## Determination 2010/004

### Firecell requirements for proposed alterations to a meatworks plant at Hokio Beach Road, Levin

- 1.4 The matter for determination<sup>3</sup> is whether the proposed alterations to a meat processing plant (“the proposed alterations”) comply with Clause C of the Building Code (Schedule 1, Building Regulations 1992).

- 2.8 The authority has indicated to the applicant that it would require additional fire safety precautions.
- 2.9 The following plan shows the main meatworks area firecell and the proposed alterations.

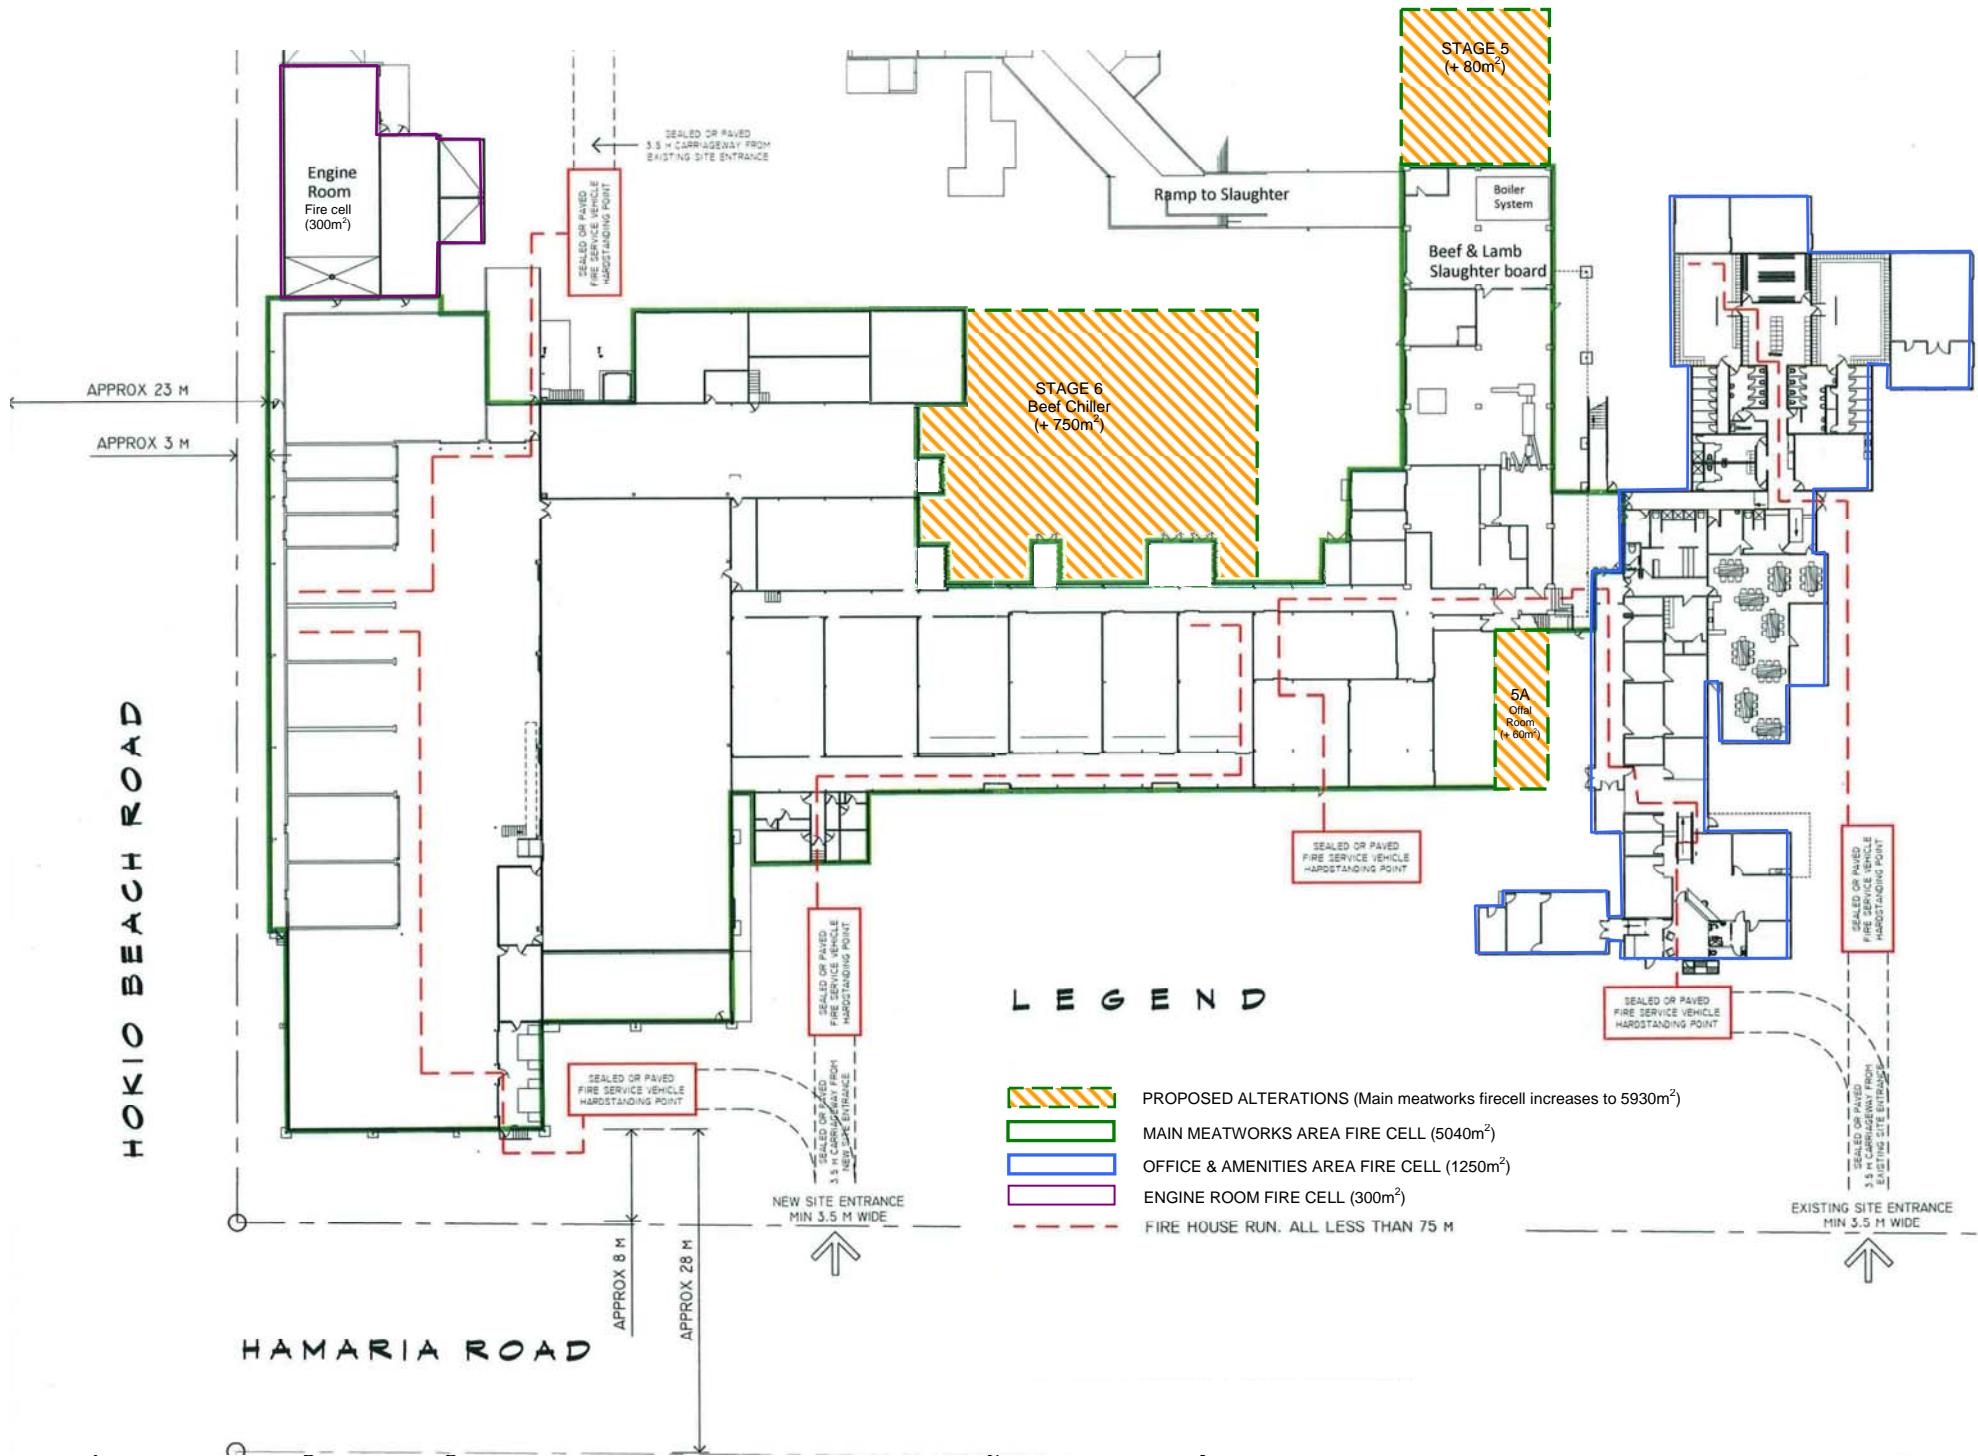
- 2.5 The proposed alterations, which equate to Stages 5-6, (Stage 4 is a rendering building away separate from the main complex) involve extending the main meatworks area with the addition of a room to the west side at the north end near the boiler system, a small offal room to the east side at the north end, and a beef chiller on the west side near the blast chillers.

- 2.6 The proposed alterations are intended to be part of the main meatworks area firecell. The main meatworks area firecell with the proposed alterations (“the proposed main meatworks firecell”) will increase the firecell from 5040m<sup>2</sup> to 5930m<sup>2</sup>.

- 7.4 The proposed main meatworks firecell does not incorporate the critical performance characteristic of roof venting to 15% of the firecell roof area (refer to Case 6 in paragraph 6.13). The supporting elements to the roof are not fire rated, and as discussed in paragraph 6.18 covering the general case, this will typically lead to roof collapse in severe fire conditions. Modification of its design would be required in order for the proposed main meatworks firecell to fall within the set of parameters prescribed within paragraph 4.2 of C/AS1.

- 7.6 In taking account of the design and the compensating features, it is my view that this design is not a code-compliant solution. In this case, one possible solution to comply with the Building Code would be to prevent portal frame collapse. As an example, the prevention of portal frame collapse may be possible by providing fire rated portal columns with base fixity, as if properly designed, this may be able to provide a capacity for ensuring catenary sag between the firecell walls.

- 9.1 In accordance with section 188 of the Act I determine that the proposed alterations do not comply with Clause C of the Building Code.
